SYDNEY NORTH PLANNING PANEL

Panel No.	2016SYE042
DA Number	LDA2016/0058
Local Government Area	City of Ryde
Street Address	6-8 Western Crescent GLADESVILLE
Proposed Development	Demolition of existing buildings and construction of a 10 storey mixed use development comprising of new facilities for the Gladesville RSL Youth Centre, 34 residential apartments and 98 parking spaces within 5 basement levels.
Applicant/Owner	Gladesville RSL and Community Club Limited
Total Submissions	Original proposal - Fifteen (15) submissions received Amended proposal – One (1) submissions received
Regional Development Criteria (Schedule 4A of the Act)	Schedule 4A(3) of EP& A Act – The development has a capital investment value of more than \$20 million. The SNPP is the Consent Authority.
List of All Relevant s79C(1)(a) Matters	<ul style="list-style-type: none"> • State Environmental Planning Policy (State and Regional Development) 2011 • State Environmental Planning Policy No. 55 (Remediation of Land) • State Environmental Planning Policy (Building Sustainability Index: BASIX) • Deemed State Environmental Planning Policy Sydney Regional Environmental Plan (Sydney Harbour Catchment) 2005 • State Environ

Figure 14: Elevation of Ross Street showing additional windows and glazing.

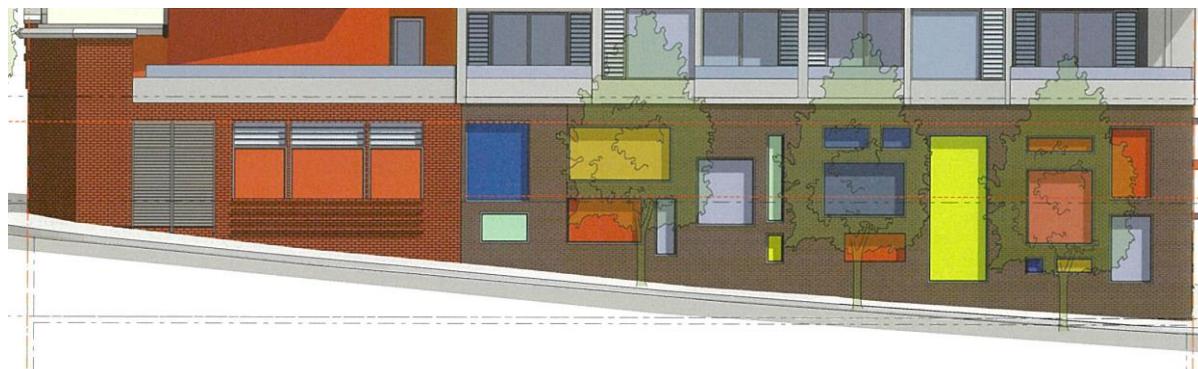
- The windows should be extended to ground and greatly enlarged. A large percentage of glazing (ideally a fully glazed façade within structural framing) would allow daylight into the gym and light from it to spill out into the street at night (safety and activation) and generally deliver an animated and visually open façade, more directly relating this important community asset to the neighbourhood. This approach could also introduce a vertical rhythm along the street and would improve its articulation. The Panel appreciates the proponent's concerns about unwanted looking in from the street and daylight/sunlight/glare issues for gym users, but believes the design of the glazing could resolve these potential problems (fritting, translucent glass, screening etc.).

Comment: In accordance with the recommendations of the Panel, the façade along Ross Street has been amended to include various window shapes and sizes with significant glazing at the ground level to achieve streetscape activation (see Figure 14 below).

Figure 22: 9am, 12pm and 3pm shadow diagrams

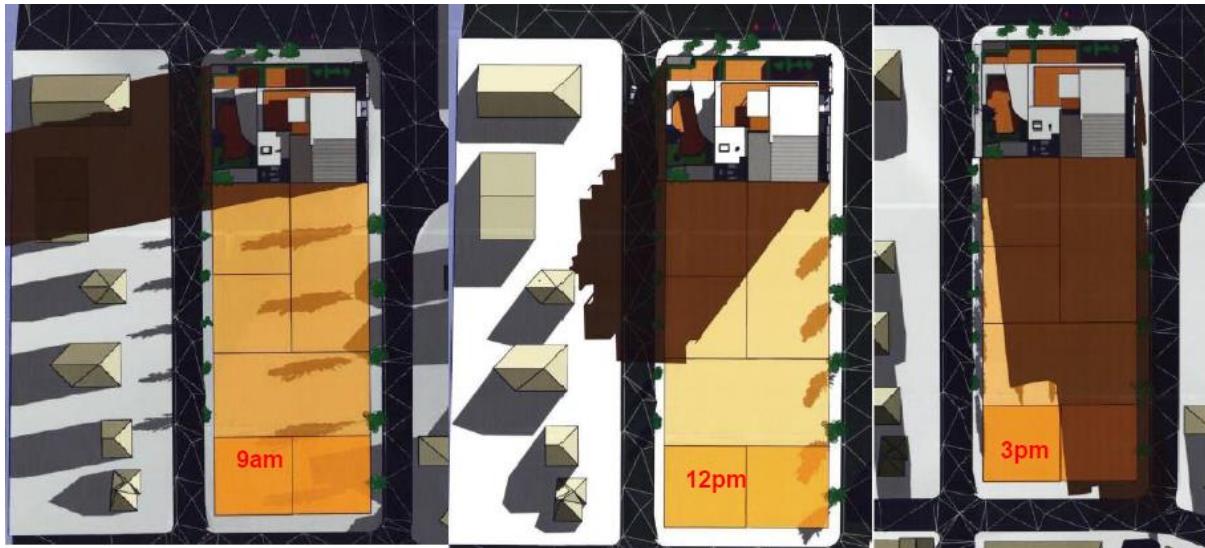
The residential buildings affected by the overshadowing in Coulter Street will only be those residential buildings located at the end of Coulter Street towards Ross Street (see Figure 22 below).

The Council car park will also receive overshadowing from the development. This overshadowing will start from 9am and will progress over the car park throughout the day. As demonstrated by the solar diagrams (Figure 22 below), the majority of the car park will receive sunlight between 9am and 12pm with parts of the site at the southern-most end of the car park having minimal overshadowing occurring from the proposed development.

Comment: The submitted shadow diagrams clearly demonstrate that the developments along Coulter Street will receive overshadowing from the proposed development between 9am and 12pm only (see Figure 22 above). Adequate solar access is provided to the developments along Coulter Street.

Figure 23: Extract of Ground floor showing 2 plant rooms.

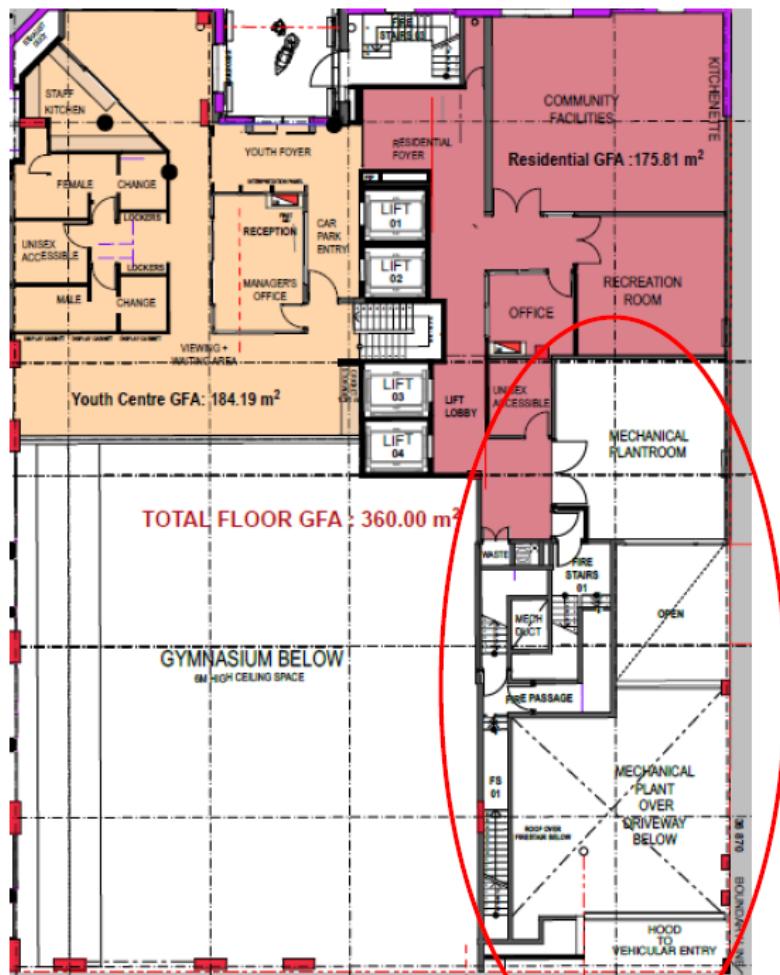
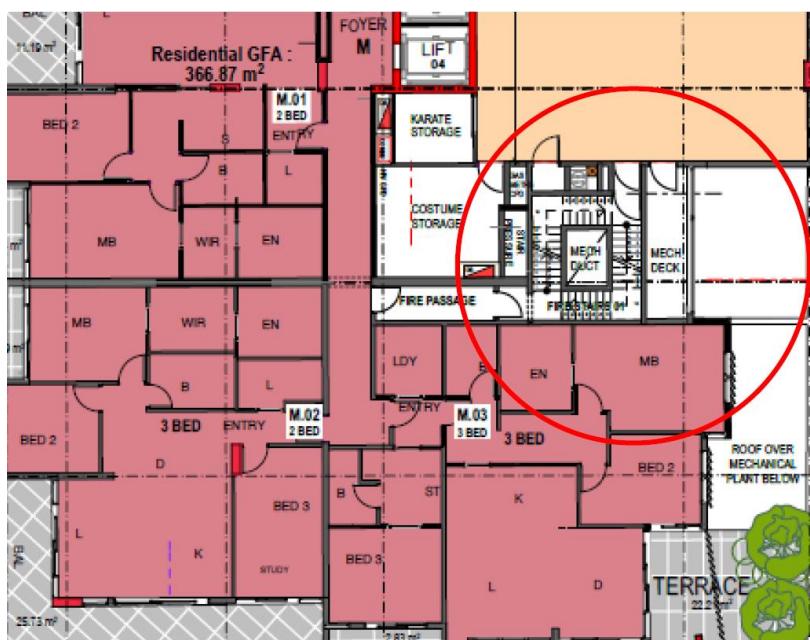
Concerns were raised by the previous Joint Regional Planning Panel regarding the size and location of the plant rooms proposed for the development. The development proposes two plants rooms on the ground floor and a smaller mechanical deck on each residential floor. This is demonstrated in Figures 23 and 24 below.

The applicant has provided a mechanical engineer's letter stating that each apartment will be air conditioned and the condenser units are proposed to be located within the mechanical deck on each floor to minimise refrigerant pipes installation. These mechanical decks are provided with privacy louvres and are setback from the boundary and are unlikely to have any visual or acoustic impacts.

Figure 25: Section through southern elevation showing mechanical plant within P1 Carpark entry roof space.

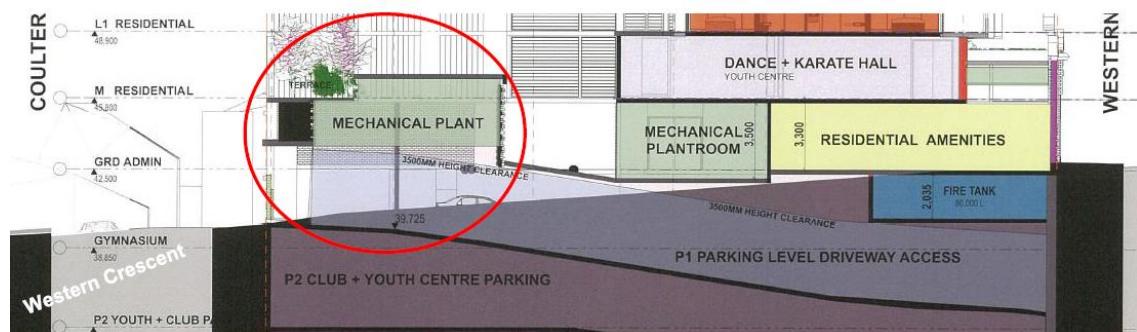
The mechanical plant over the driveway is not proposed to be a plant room. The sections provided by the applicant shows that the mechanical plant over the driveway is intended to be within the roof space of the driveway entry into P1 Level. This is demonstrated in Figure 25 below and has been confirmed in a statement provided by the mechanical engineer for the development.

In terms of acoustic issues a condition has been imposed requiring acoustic treatment of the development to ensure amenity levels both within and without the development is maintained (see condition 58).
